DEVELOPMENT REVIEW COMMITTEE (DRC) COMMENT REPORT

PROJECT NAME: Davie 1

CASE NUMBER: R19046

REQUEST: Site Plan Level III Review: Conditional Use for a Mixed-Use Development in Community Business (CB) District with 48 Residential Flex Units and 3,000 Square Feet Retail Use, and 12 Residential Units in Residential Multifamily Mid Rise / Medium High Density (RMM-25) District

Exhibit 1: Conceptual Design of Mixed-Use Building with Residential and Commercial Uses

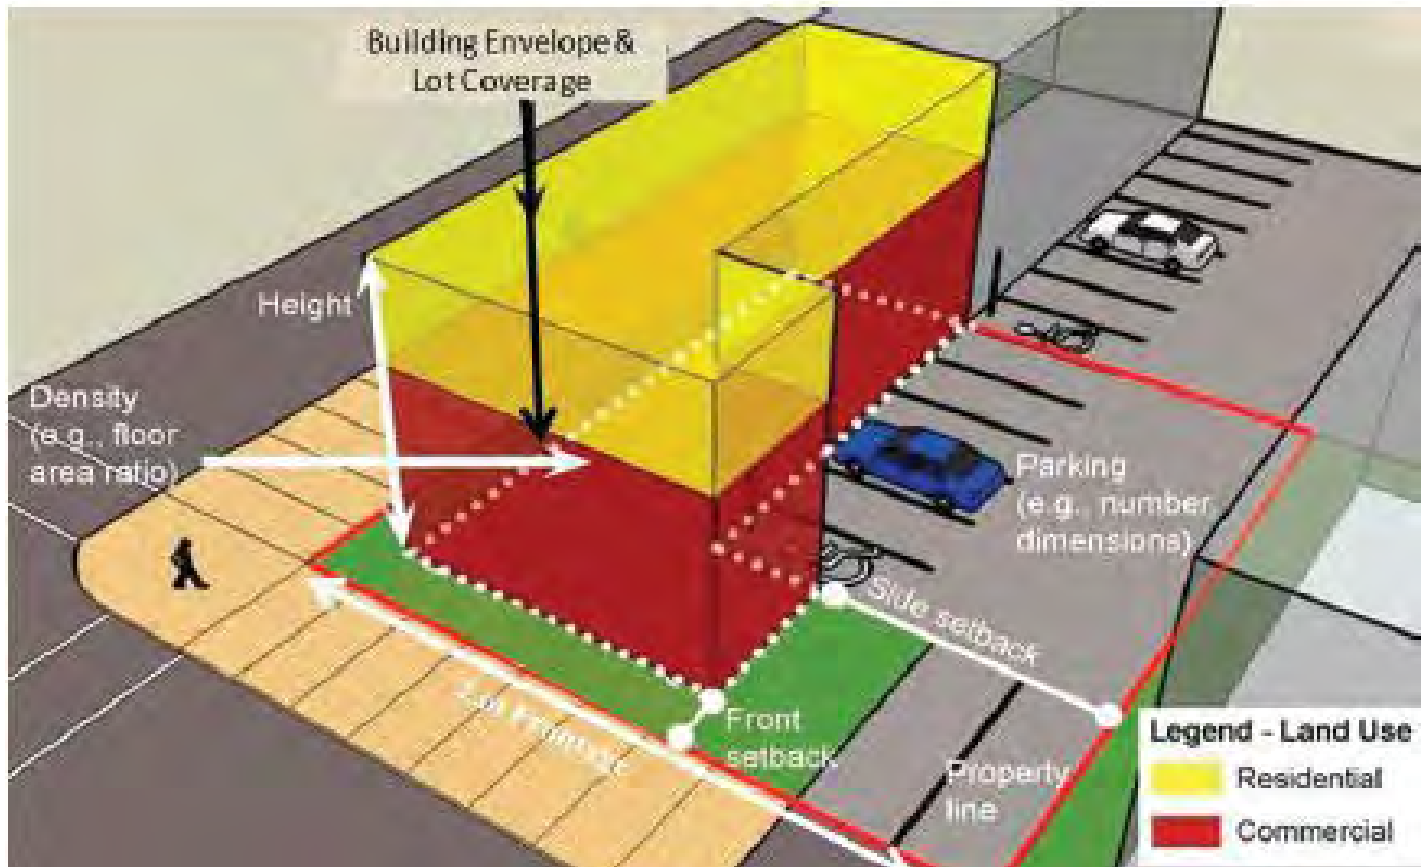
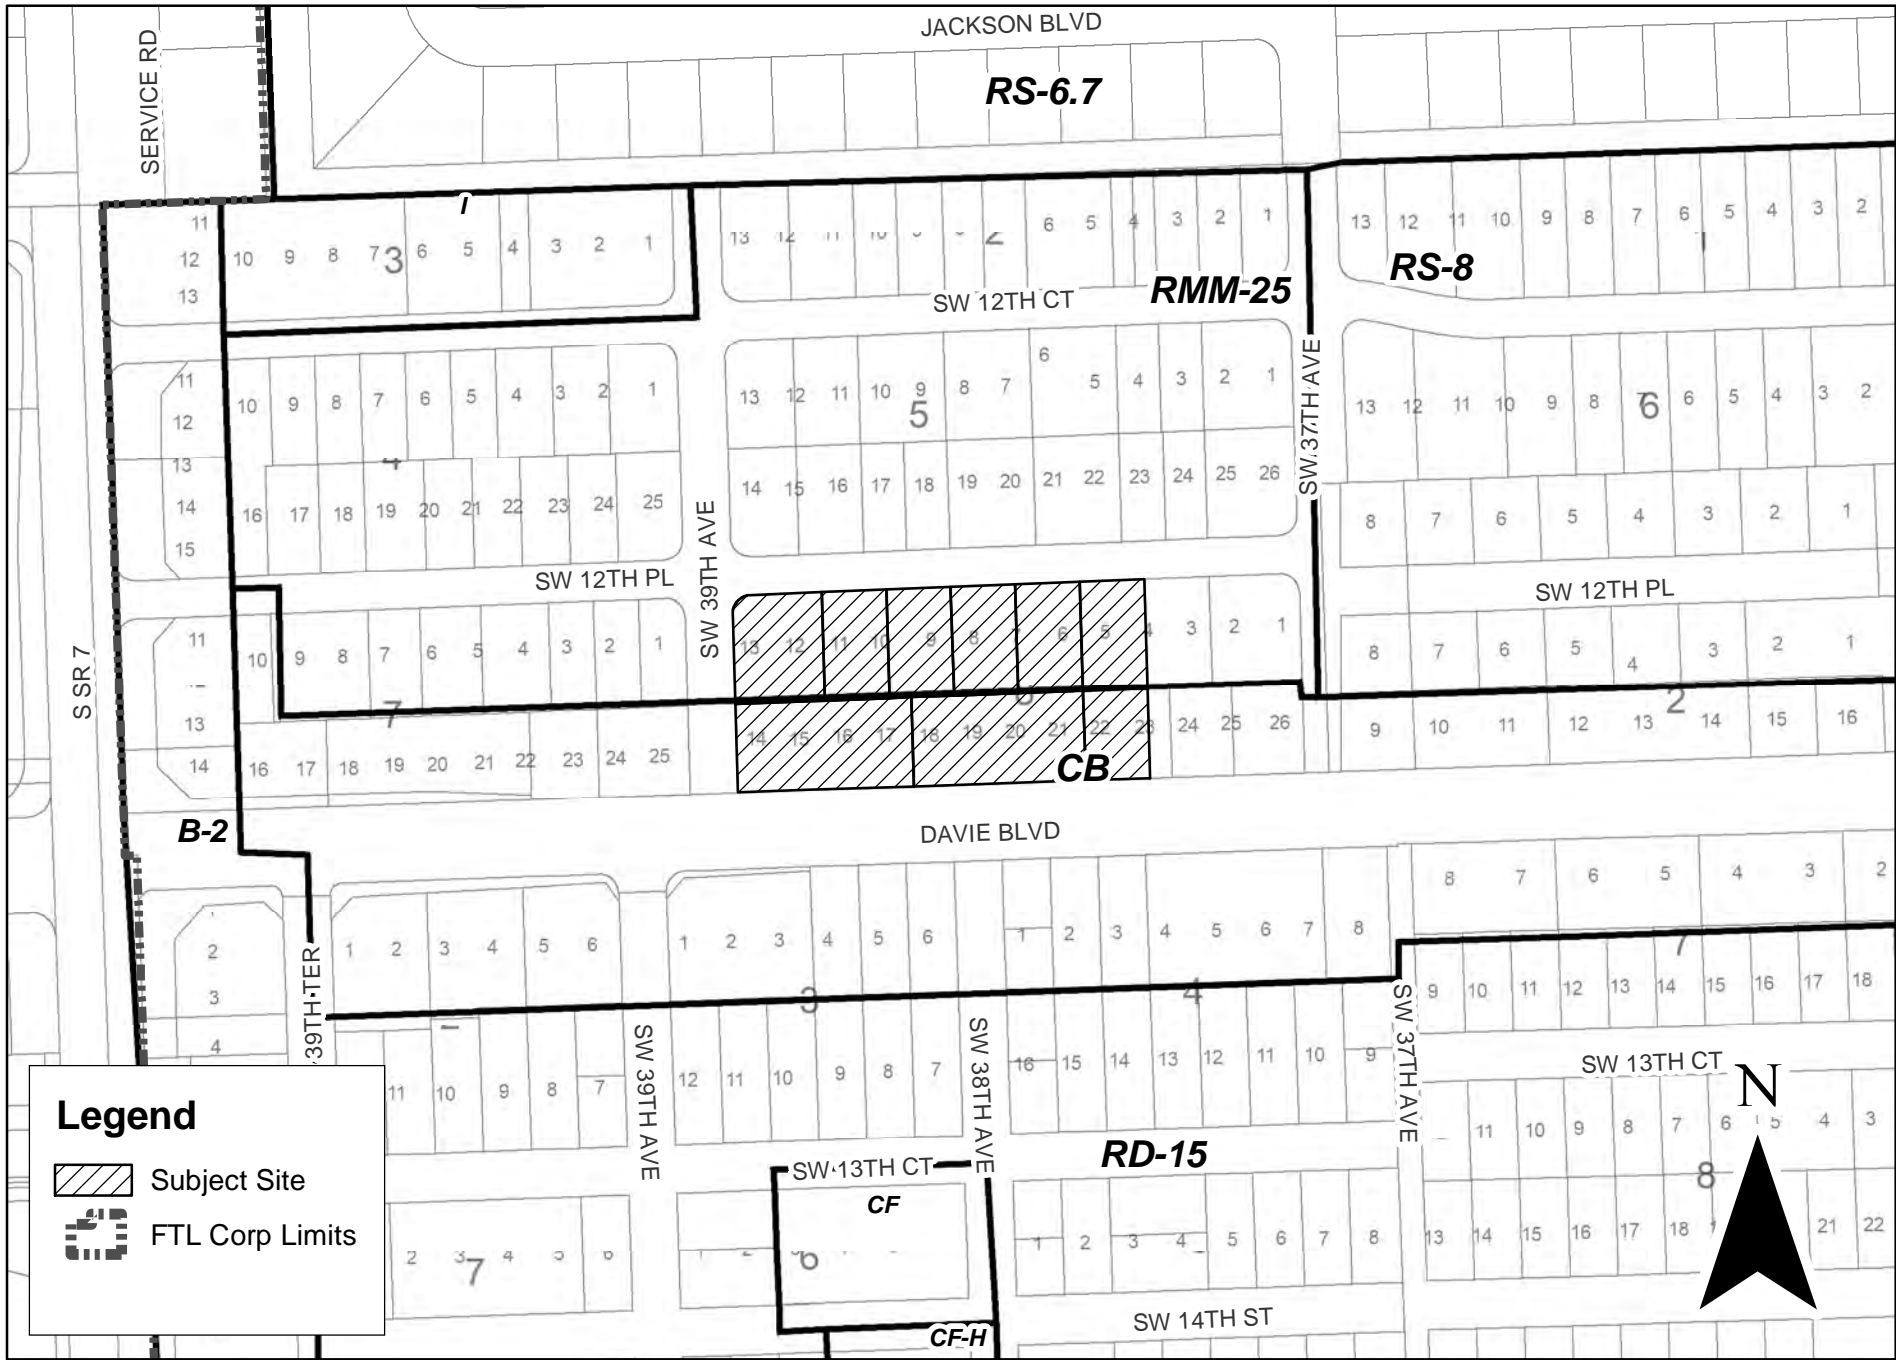
- h. Section 47-25.3.3.e. Neighborhood Compatibility and Preservation, places importance on ensuring development is compatible with, and mitigates adverse impact to, nearby adjacent neighborhoods, which include the "placement or orientation of buildings and entryways, parking areas, bufferyards, and alteration of building mass", etc. Based on the characteristics of the site consider the following site layouts. Reference Exhibit 1 and Exhibit 2:

- i. To create a natural transition from the commercial corridor of Davie Boulevard into the residential neighbor located north of the proposed development, consider an internalized
